# Access Compliance Report

## Public Rights-of-Way

### (Curb Ramps)

Intersection ID: 42459	Main Street: KINGSLEY_VIEW_DR	Cross Street: KING_LOUIS_CT	Location: NE
ADA ID: 906E724A99EC	Ramp Type: PerpDiag	Initial Pass/Fail: Fail	Overall Compliance: No
Severity Score: 17.5			
Codes/Mitigation Info/Possible Solution		Field Measurements/Component Compliance

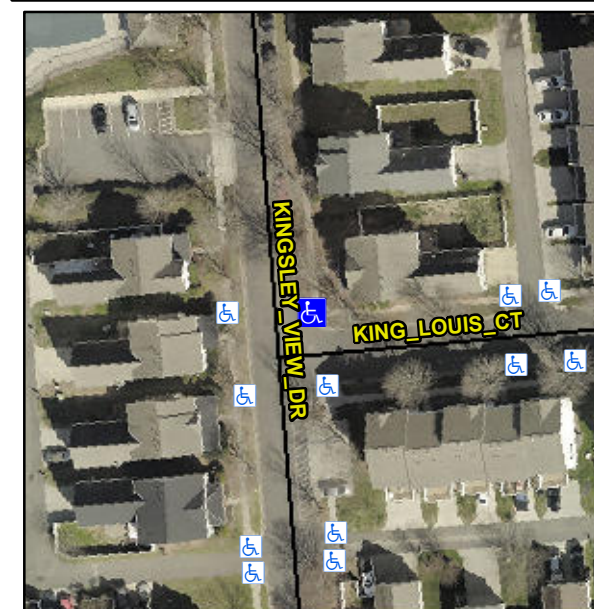
**Not Found, R304.5.1**

Compliance	Description	Data	Compliance	Description	Data
N/A	Ramp Length (in)	71.0	Yes	Ramp Slope (%)	6.4
No	Ramp Width (in)	35.0	Yes	Ramp XSlope (%)	1.0
N/A	Flare Type LT	N/A	N/A	Flare Type RT	N/A
N/A	Flare Slope LT (%)	N/A	N/A	Flare Slope RT (%)	N/A
N/A	Flare Traversable LT?	N/A	N/A	Flare Traversable RT?	N/A
N/A	Landing Length (in)	N/A	N/A	DWS Provided?	N/A
N/A	Landing Width (in)	N/A	N/A	DWS Contrast?	N/A
N/A	Landing Slope (%)	N/A	N/A	DWS Length (in)	N/A
N/A	Landing X Slope (%)	N/A	N/A	DWS Full Width?	N/A
N/A	Landing Curb? (Y/N)	N/A	N/A	DWS Offset (in)	N/A
N/A	Shared Landing?	N/A			
N/A	Gutter Ponding?	N/A	N/A	Gutter Slope (%)	N/A
N/A	Gutter Lip Ht (in)	N/A	N/A	Gutter X Slope (%)	N/A
N/A	Painted X Walk1?	No	N/A	Painted X Walk2?	No
	X Walk 1 Direction	To W		X Walk 2 Direction	To S
N/A	X Walk 1 Width (in)	N/A	N/A	X Walk 2 Width (in)	N/A
	X Walk 1 Slope (%)	2.1		X Walk 2 Slope (%)	2.1
	X Walk 1 X Slope (%)	2.0		X Walk 2 X Slope (%)	0.4

**Remove & Replace Curb Ramp With Two New Directional Ramps or Equivalent.**
